ZONING CHANGE REVIEW SHEET

CASE: C814-2014-0120 – Austin Oaks Planned Unit Development

Environmental Commission Date: September 6, 2016

EXHIBIT C

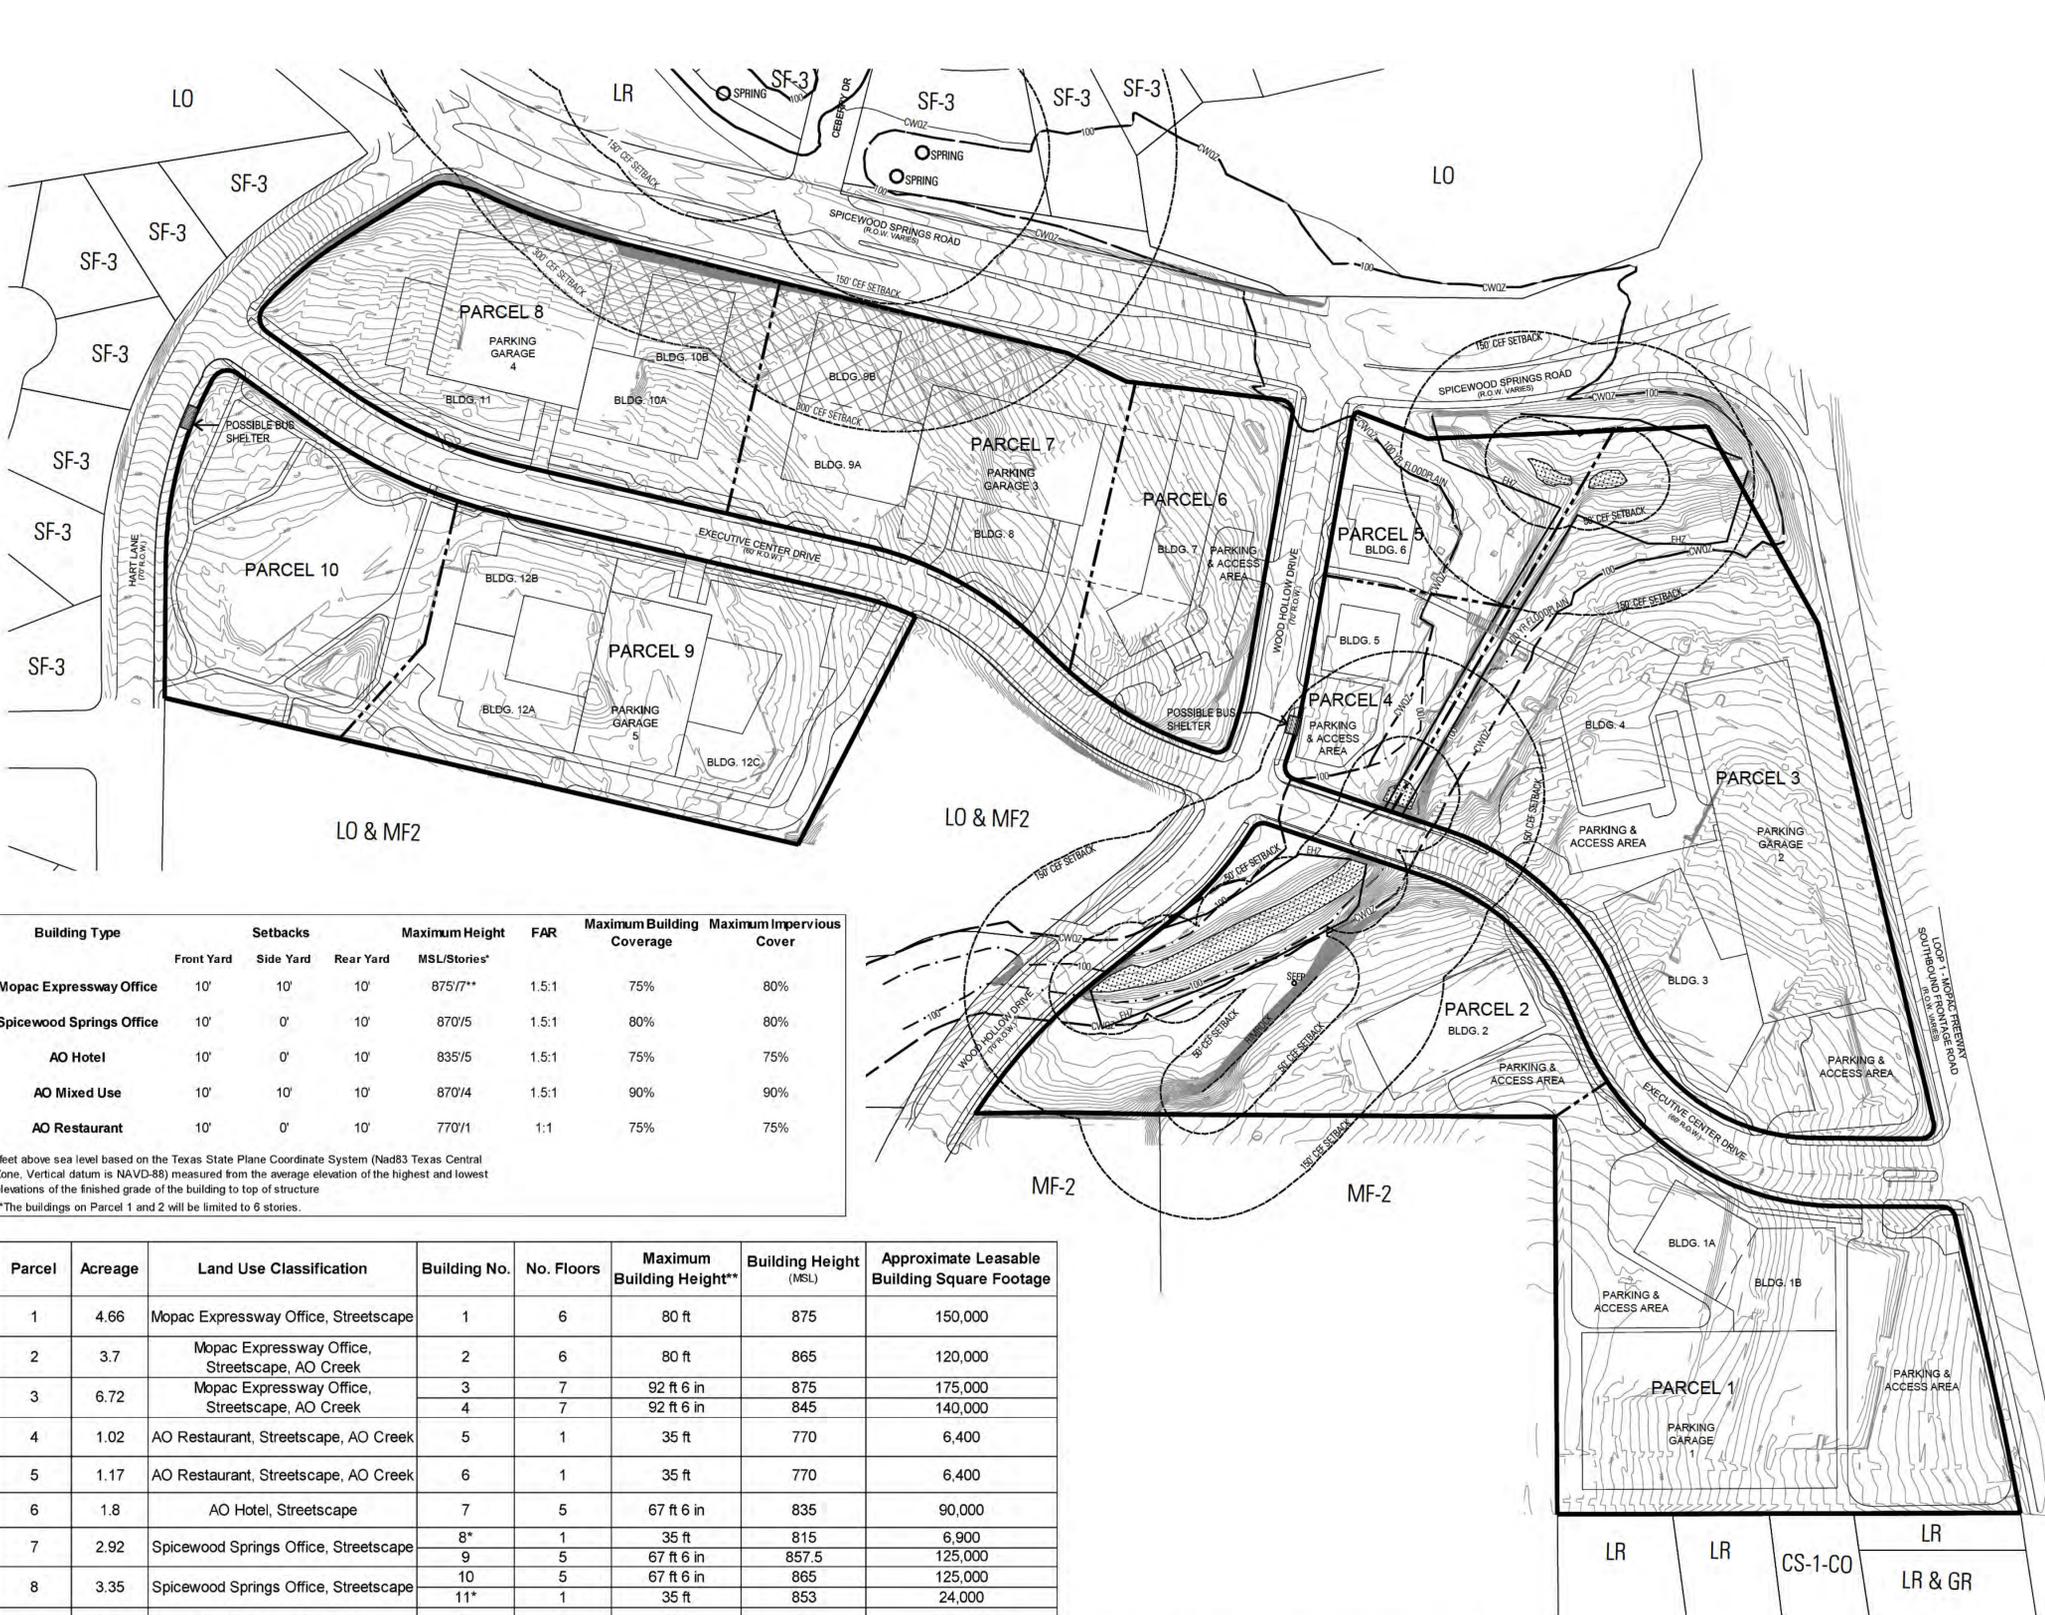
EO 15. The CWQZ, 100-year floodplain, and CEF buffers are difficult to read on this plan. Please revise the symbology to better illustrate the environmental features on the land use plan. Can the Erosion Hazard Zone and Drainage Easements be removed to make the plan easier to read?

Update 4: Under 25-8-92(F), the boundaries of a CWQZ in an urban watershed coincide with the boundaries of the 100-year fully developed floodplain, with a minimum width of 50' and a maximum width of 400'. There are several places where the 100-year fully developed floodplain extends beyond the identified CWQZ. Please correct the CWQZ boundaries to follow the 100-year fully developed floodplain in areas where the floodplain width is between 50' and 400' from the creek centerline. (Maintain a minimum CWQZ width of 50' where the floodplain is narrower than 50' from centerline.)

Update 5: Comment cleared.

EXHIBIT F

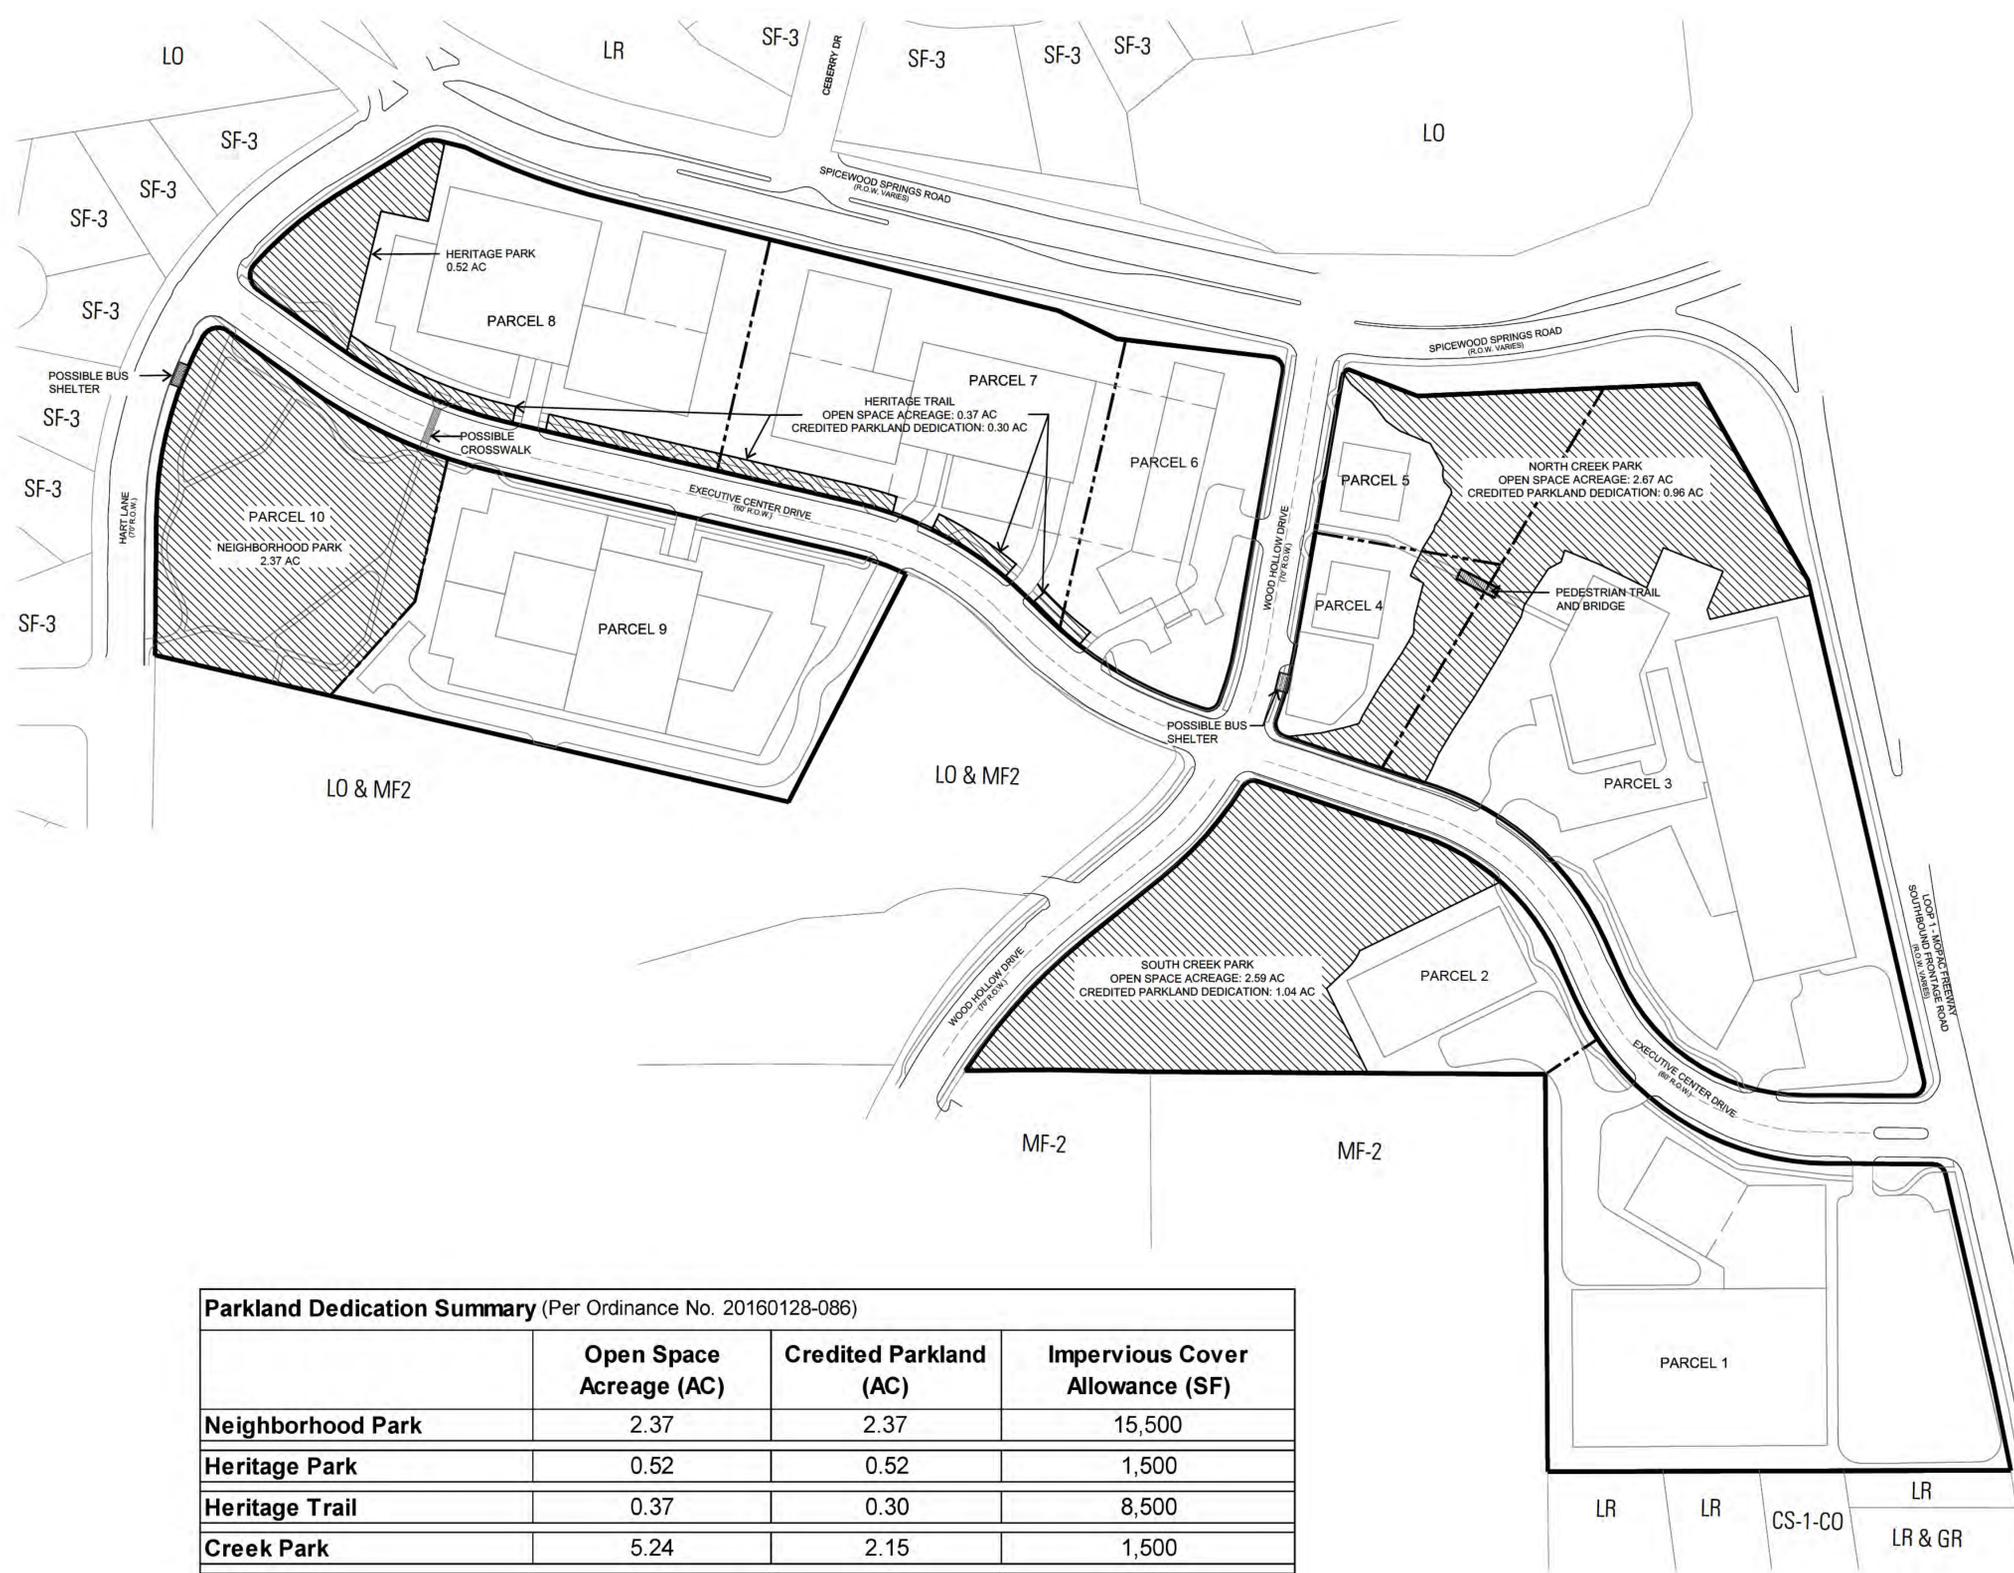
EO 34. The Parkland Dedication Summary table allocates 14,000 square feet of impervious cover for the Creek Park. Is this number intended to include the trail? If the trail is public it will not count towards the impervious cover limit; however, the square footage of noncompliant development does need to be calculated and incorporated into the PUD. Please clarify whether the 14,000 square feet includes the trail and if so, provide the estimated size of the trail. Any requested park development that would not comply with CWQZ or CEF buffer requirements should be subtracted from the proposed restoration area. See comment EO 7.

Update 5: Comment cleared.

STREAM LAYING BACK SECTION
SCALE: 3"=1'-0"

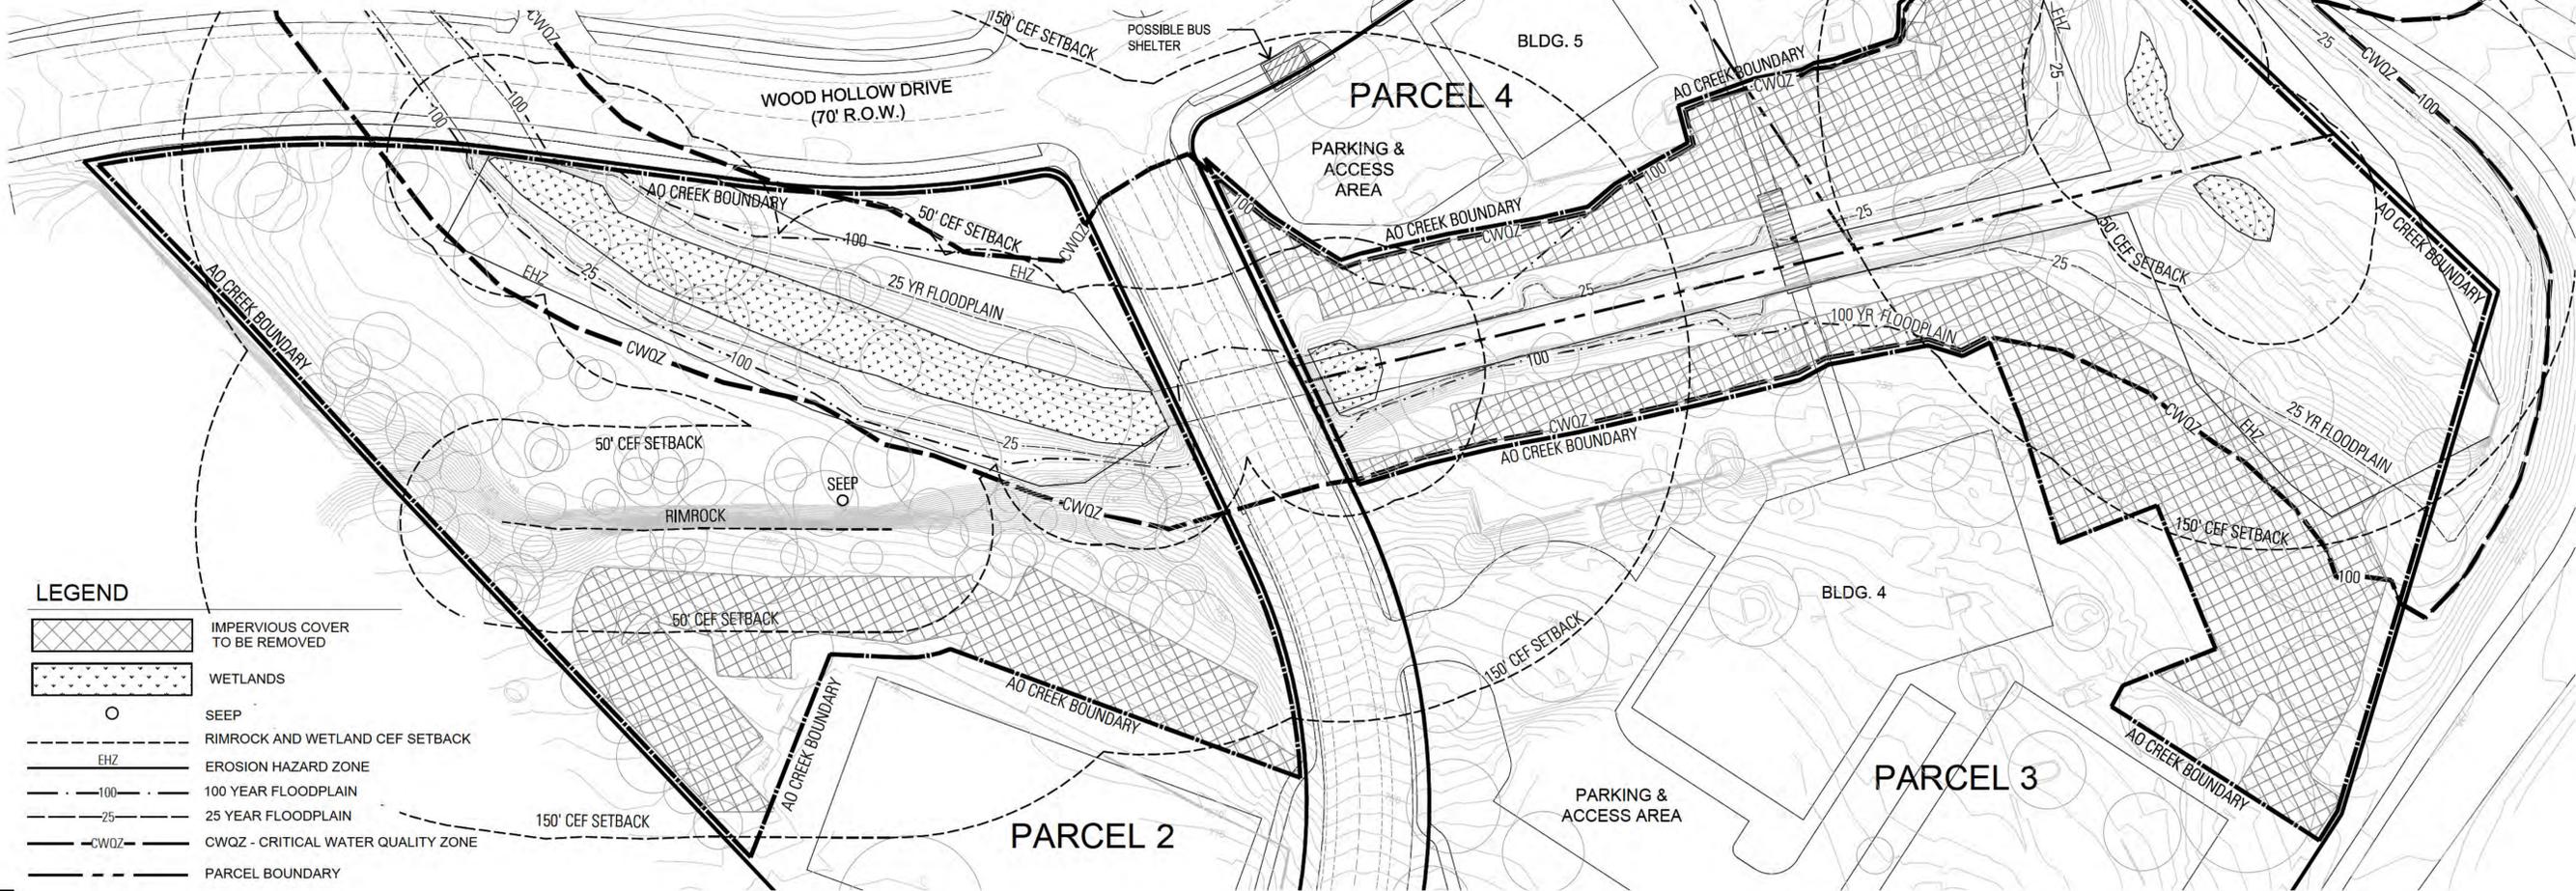
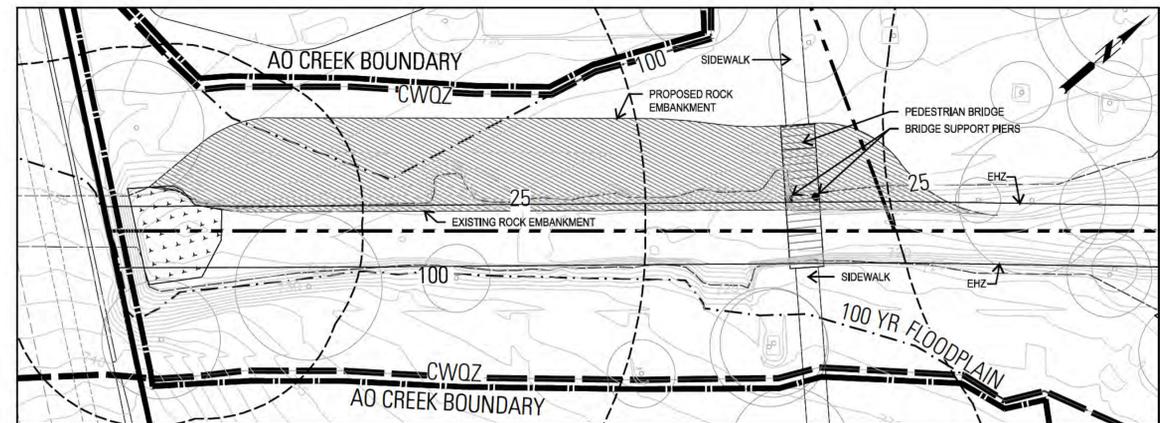
EO 17. As noted in EO [15], the boundaries on this exhibit are difficult to read. Please revise the symbology to better illustrate the environmental features and restoration areas, and remove any information that is not necessary for PUD review (e.g., EHZ, drainage easements, etc.).

Update 4: There are several places where the 100-year fully developed floodplain extends beyond the identified CWQZ. Please correct the CWQZ boundaries to follow the 100-year fully developed floodplain in areas where the floodplain width is between 50' and 400' from the creek centerline. (Maintain a minimum CWQZ width of 50' where the floodplain is narrower than 50' from centerline.)

EO 18. Please delete notes 1, 2, and 5, and delete or revise notes 3, 4, and 6 to reflect requested changes to the superiority table. All significant elements of the PUD proposal should be included in either the superiority table or a code modification table. Notes on the exhibit can repeat,

Update 4: Update the restoration language in Note 2 to match the staff suggestion above. Please add a note specifying that the proposed pedestrian bridge must span the erosion hazard zone with one set of piers within the creek channel if necessary.

Note 2 and the restoration language suggested above only apply to areas within the CWQZ and CEF buffer. There are some areas where impervious cover will be removed that are outside of the CWQZ and CEF buffer. Staff suggests specifying that areas outside of the CWQZ and CEF buffer will be planted and seeded pursuant to Standard Specification 609S, but that those areas do not need to achieve a score of “Good” under the floodplain modification parameters.

Update 5: Comment cleared.
